Re: Puget Sound Energy 2021 Draft Integrated Resource Plans for Electricity and Natural Gas,
Dockets UE-200304 (electricity) and **UG-200305** (natural gas)

The NW Energy Coalition (“NWECC” or “Coalition”) appreciates the opportunity to comment on the draft Integrated Resource Plan (“IRP”) submitted by Puget Sound Energy (“PSE”) on January 4th, 2021, as provided by the Notice of Opportunity to File Written Comments issued January 5th.

Figure 3-2: Draft Preferred Portfolio Meeting Electric Peak Capacity

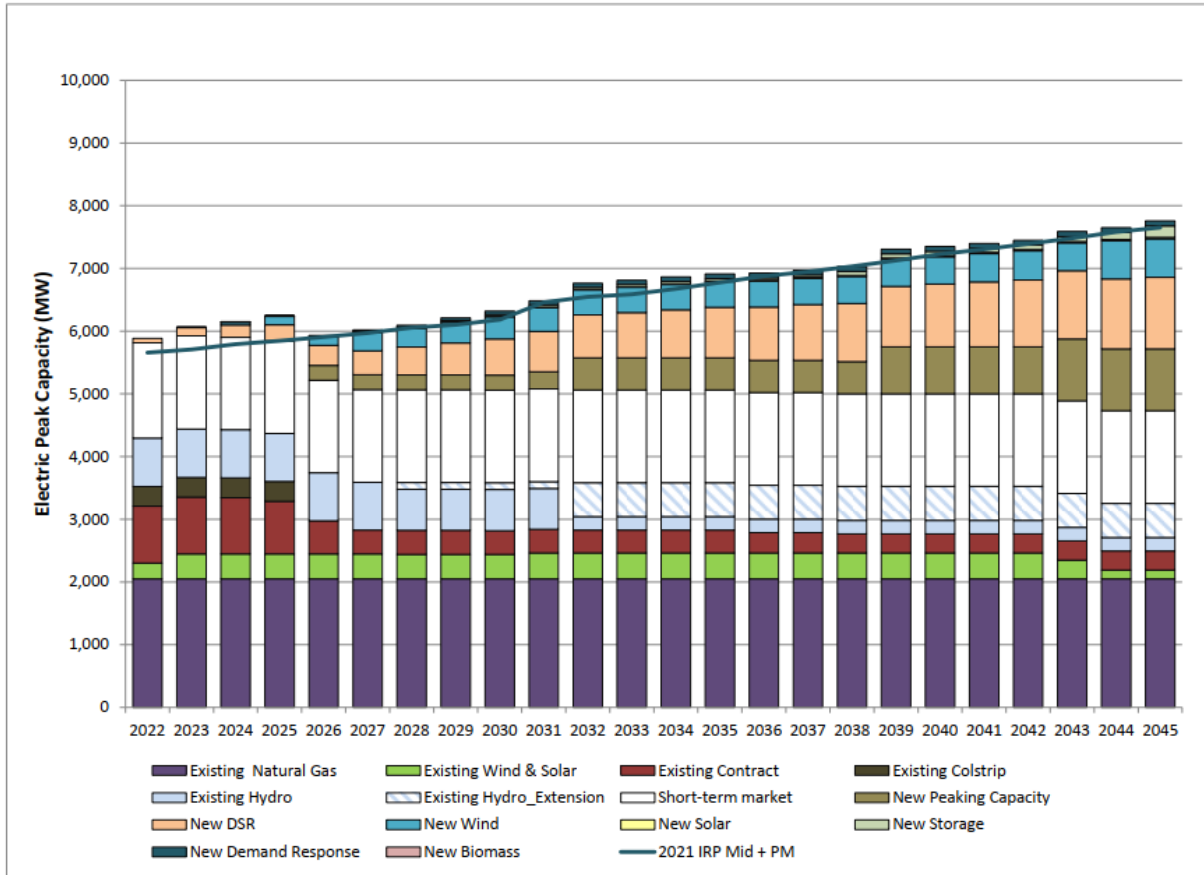
In 2027, the draft IRP indicates a need for 527 MW of capacity after inclusion of existing resources and new demand side resources. The draft proposes to fill this gap with 1100 MW of new wind, a small amount (around 20 MW) of demand response, and a 237 MW natural gas peaking plant (combustion turbine). These are estimates based on Figure 3-2, because the IRP only provides specific data for new resource additions in multi-year blocks, not annual values (Figure 3.1).

As we note in the following discussion, the 2027 resource additions do not provide a balanced new resource portfolio. In particular, the need for a new gas peaker is considerably in doubt.

Figure 3-14: Loss of Load Hours for 2027

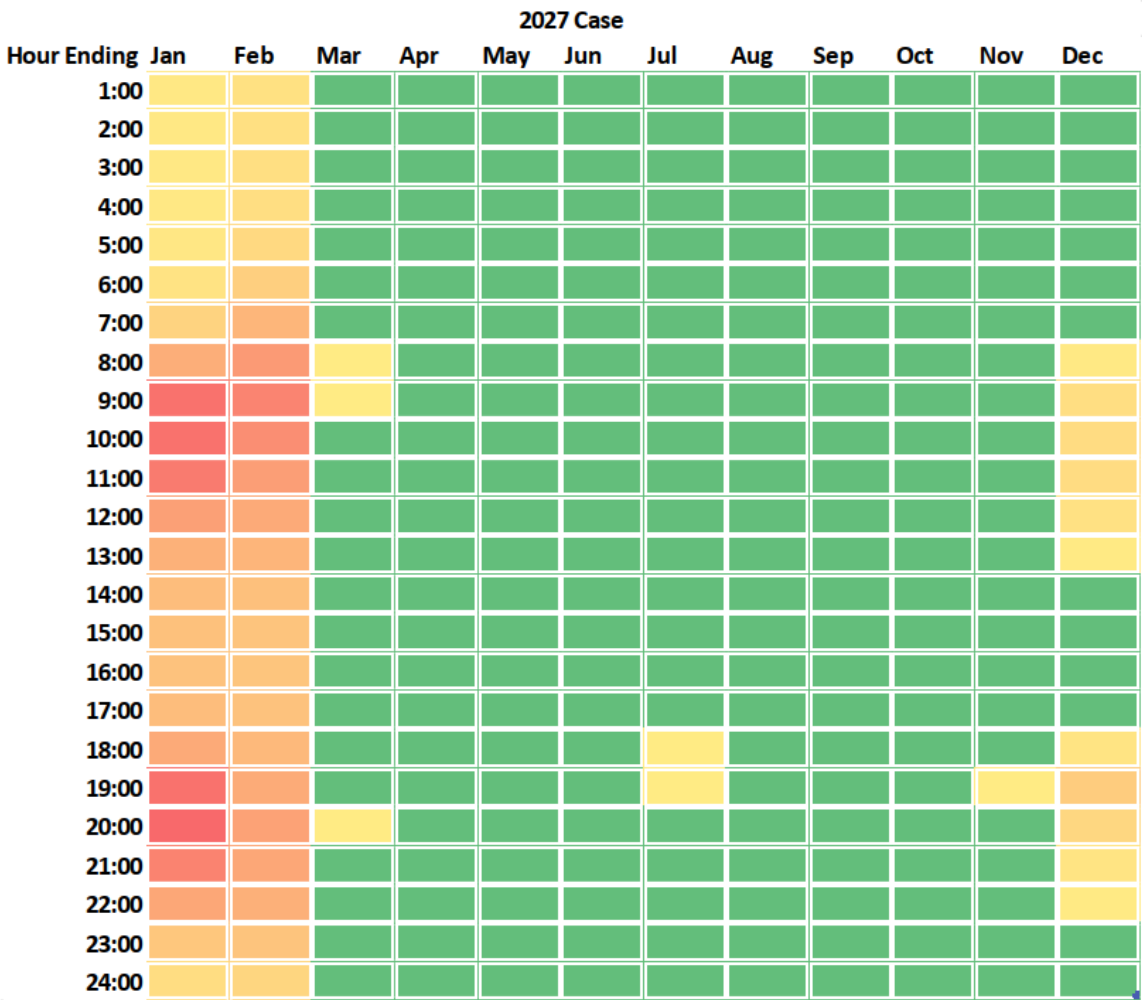
Figure 3-14 illustrates the challenge, showing stress conditions based on peak load duration in 2027. These conditions do not occur year-round, but almost entirely in the mid-winter quarter from December to February.

The draft IRP proposes to fill the 2027 gap with peak-oriented renewable resources -- primarily Montana wind, providing CETA-compliant clean energy up to the limit of available transmission -- a small amount of demand response, and a new 237 MW natural gas peaker plant. The question we pose is whether a staged approach to capacity need could provide a new balanced 2027 resource portfolio that is better aligned with CETA policy guidance while meeting reliability needs cost-effectively:

CAISO (California ISO)
Day-Ahead Price

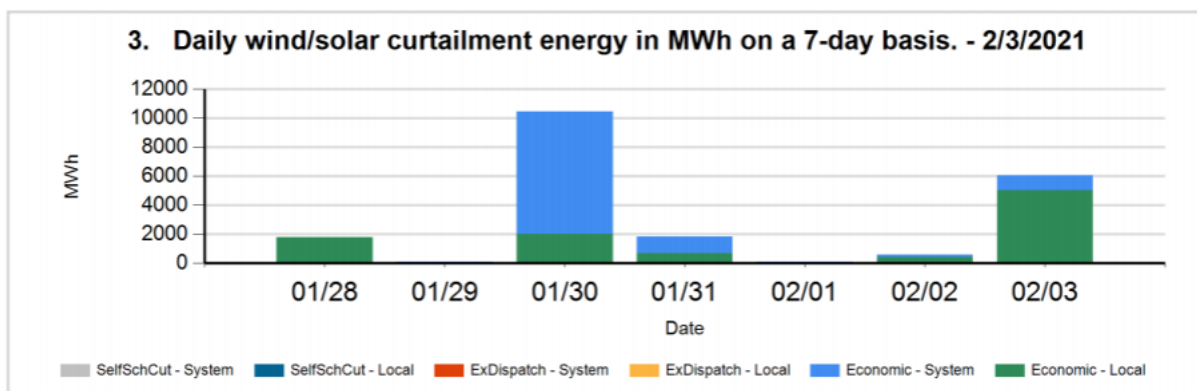
For example, on Feb. 3, California ISO day-ahead market prices averaged less than \$20/MWh between 10 am and 3 pm. In addition to substantial standby gas capacity, mid-day solar is often curtailed during the winter, providing another source of very cheap and clean energy. In the past week over 2,000 MWh/day of solar was curtailed in CAISO for economic reasons. PSE should study the potential for acquiring California winter surplus to meet winter peak needs. The exact form of such purchases requires considering a range of term offers, but we provide a back-of-the-envelope example.

Example: Assume 250 MW of firm energy for 100 midwinter on-peak hours delivered from California for \$100/MWh including transmission wheeling charges. That amounts to \$2.5 million per year. With the availability of sufficient flexible load and storage resources, instead of buying on peak hours, California surplus could be acquired in the very low-cost mid-day period with a much higher renewable energy content. All this suggests that imports could be far cheaper than a new gas peaker.
